Subject: Submittal of Topical Report BAW-10199P, Addendum 1, "The BWU Critical Heat flux Correlations," December 2000.

SUBJECT: ACCEPTANCE FOR REFERENCING OF LICENSING TOPICAL REPORT
BAW-10199P, ADDENDUM 1, "THE BWU CRITICAL HEAT FLUX
CORRELATIONS" (TAC NO. M96728)

TOPICAL REPORT BAW-10199P, ADDENDUM 1

**BAW-10199P-A, The BWU Critical Heat Flux Equations,
Addendum 1:**

Figure Q1b-1
Mark B11 Replicate Data Base with $F_{B11} = 0.98$

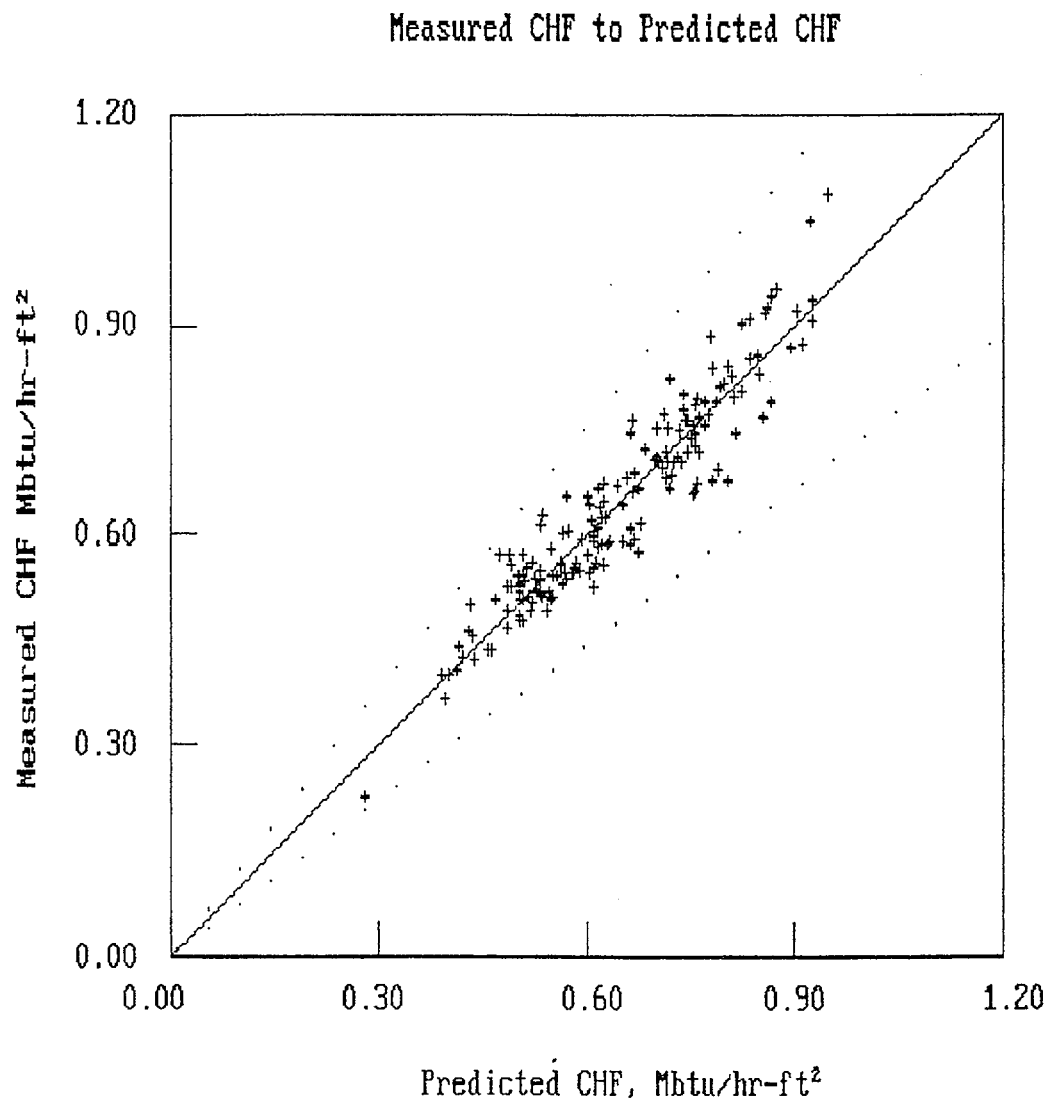
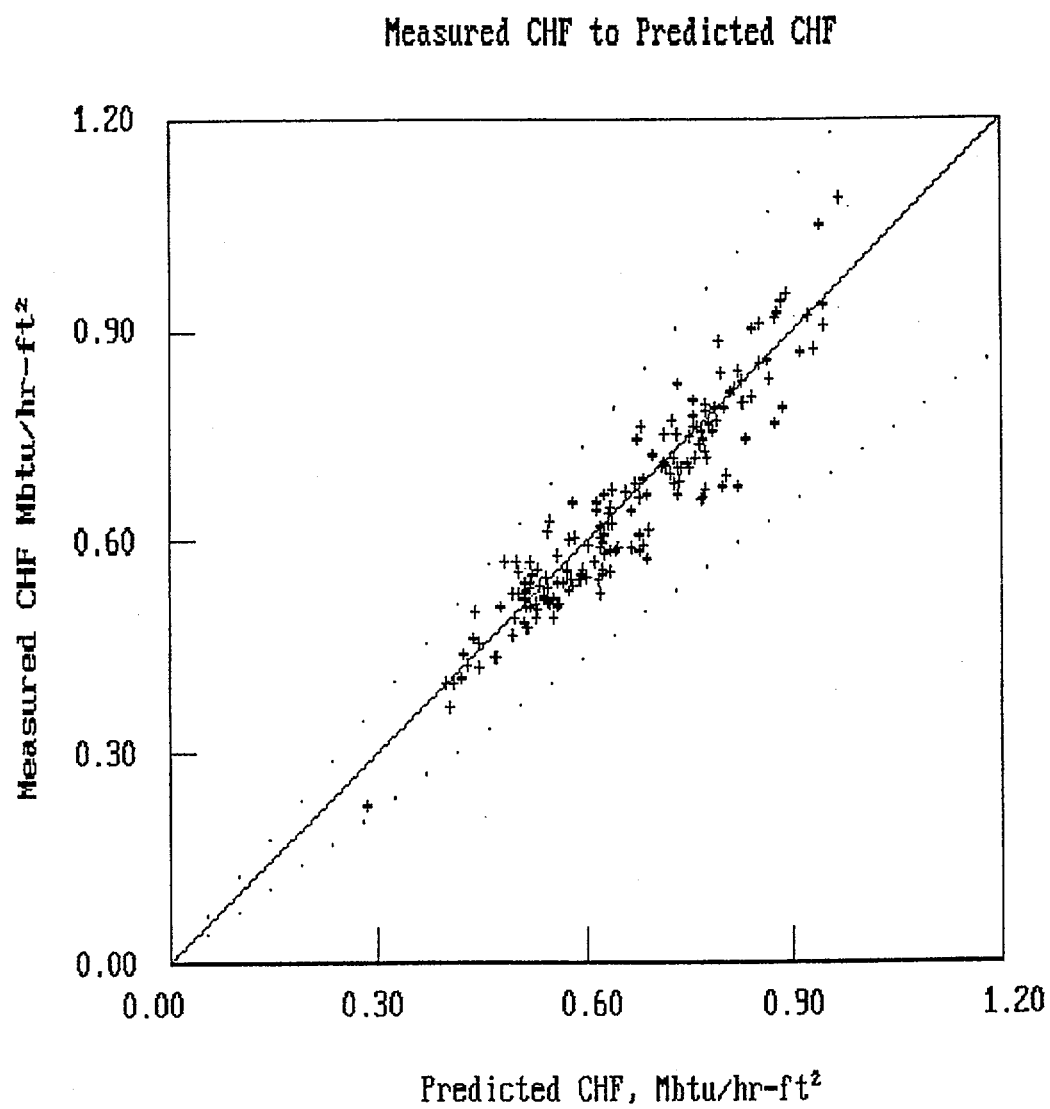
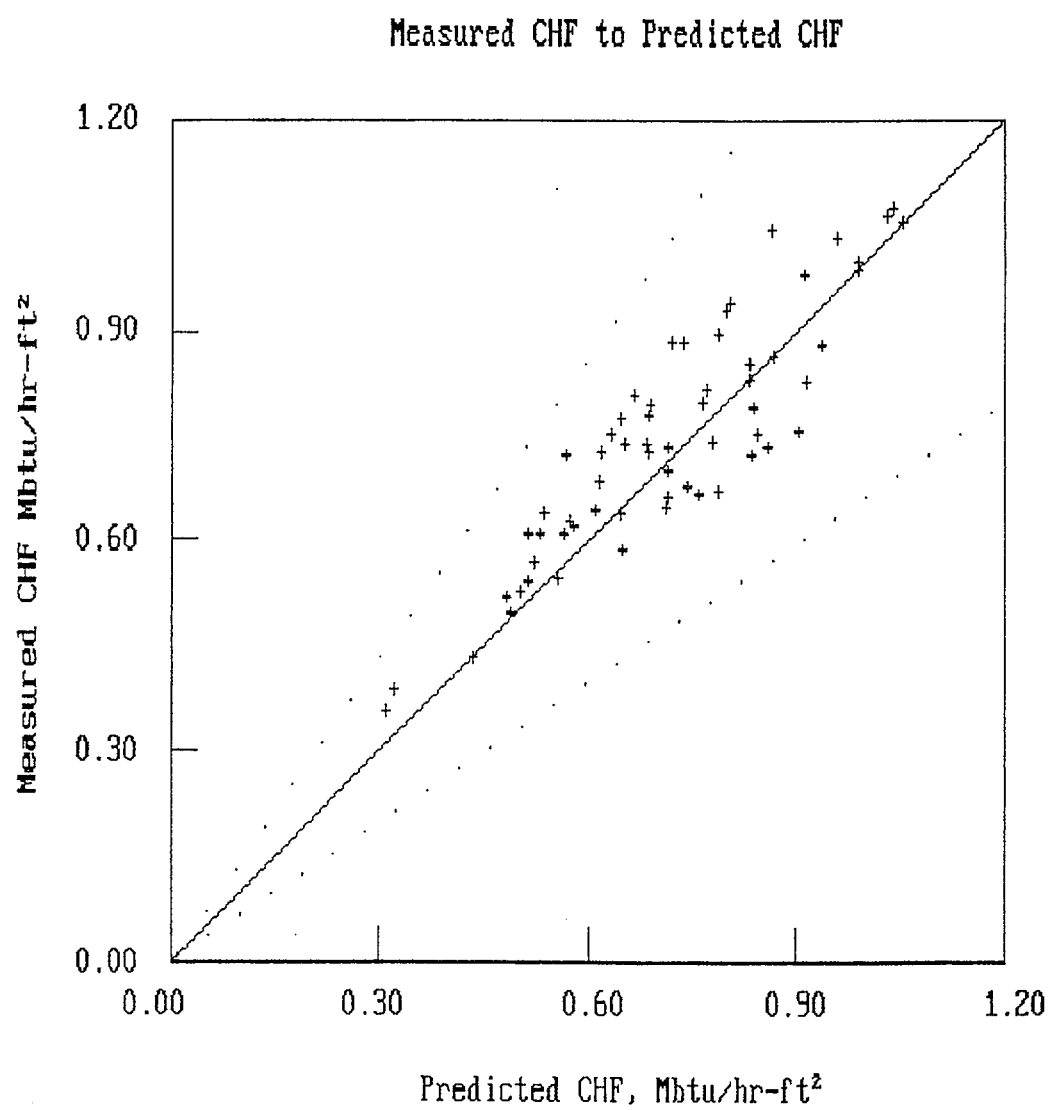
1. *The response to Question 3 dated February 23, 1998, states that no bias was found when the B11 and BW17-MSM data bases were analyzed with the BWU-Z correlation, and only the "average levels" were different. Please provide information supporting this conclusion, in the form of*

Figures Q1b-1 and Q1b-2 show measured CHF versus predicted CHF plots of the Mark B11 replicate data set with $F_{B11} = 0.98$ and 1.0 respectively. Figures Q1b-3 and Q1b-4 show these plots for the Mark BW17-MSM replicate data set with $F_{MSM} = 1.15$ and 1.0 respectively. Finally, for reference, Figure Q1b-5 shows the measured versus predicted plot

Examination of the plots with normalization factors (Figure Q1b-1 and Figure Q1b-3) shows that the individual points are grouped evenly about the 45 degree inclined line (where the measured CHF exactly matches the predicted CHF) and all values are well within the ± 3.5 standard deviation limits. For the unnormalized plot with $F_{B11} = 1.0$ (Figure Q1b-2), the average individual value is below the 45 degree line, while for Figure Q1b-4 (with $F_{MSM} = 1.0$) it is well above it. This deviation from scatter centered about the 45 degree line indicates the need for a normalization factor (i.e., F_{B11} and F_{MSM} respectively). Finally, the normalized measured versus predicted plot (utilizing $F_{B11} = 0.98$ and $F_{MSM} = 1.15$) show no bias with respect to absolute CHF level. That is, the spread about the 45 degree line is relatively constant (on a percentage basis) over the whole range of measured heat fluxes.
